ADDENDUM NO. 1

RE: March 24, 2022 Rapid City Region Office Informal Letting
385-451, 016EB-452 & 090W-452, Jackson, Lawrence & Pennington County
PCN i6m0, i6lx & i6ly
Erosion Control at various locations

STATE OF SOUTH DAKOTA	PROJECT	SHEET	TOTAL SHEETS
	385-451, 016EB-452, 090W-452	8	24

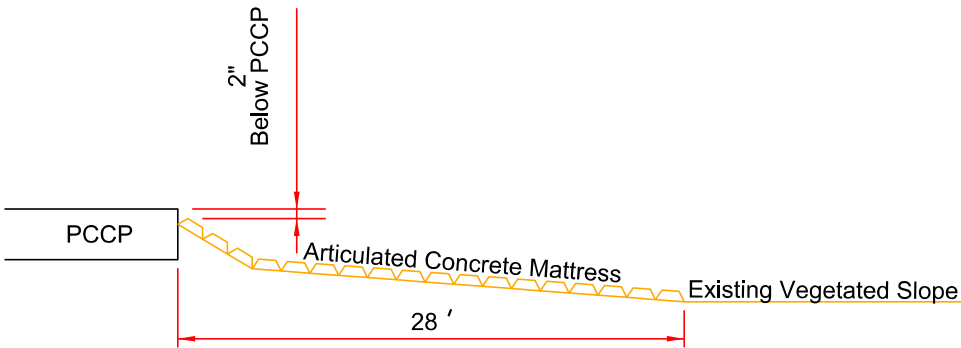
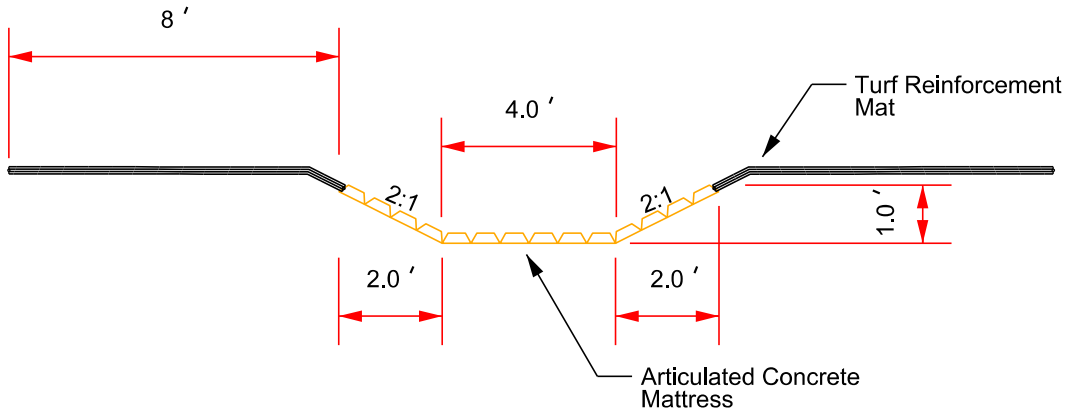
- Replace Sheets 2,5,8 and 9 with the attached. The width for Turf Reinforcement Mat was changed to 8'. Revised quantity of Type 1 Turf Reinforcement Mat is now 86 sqyds.

Station	Location	L/R	Width (Ft)	Type	Quantity (SqYd)
016E B-452 MRM 64.7	Ditch	L	8	1	18
016E B-452 MRM 64.7	Ditch	R	8	1	18
016E B-452 MRM 64.2	Ditch	L	8	1	25
016E B-452 MRM 64.2	Ditch	R	8	1	25
Total:					86
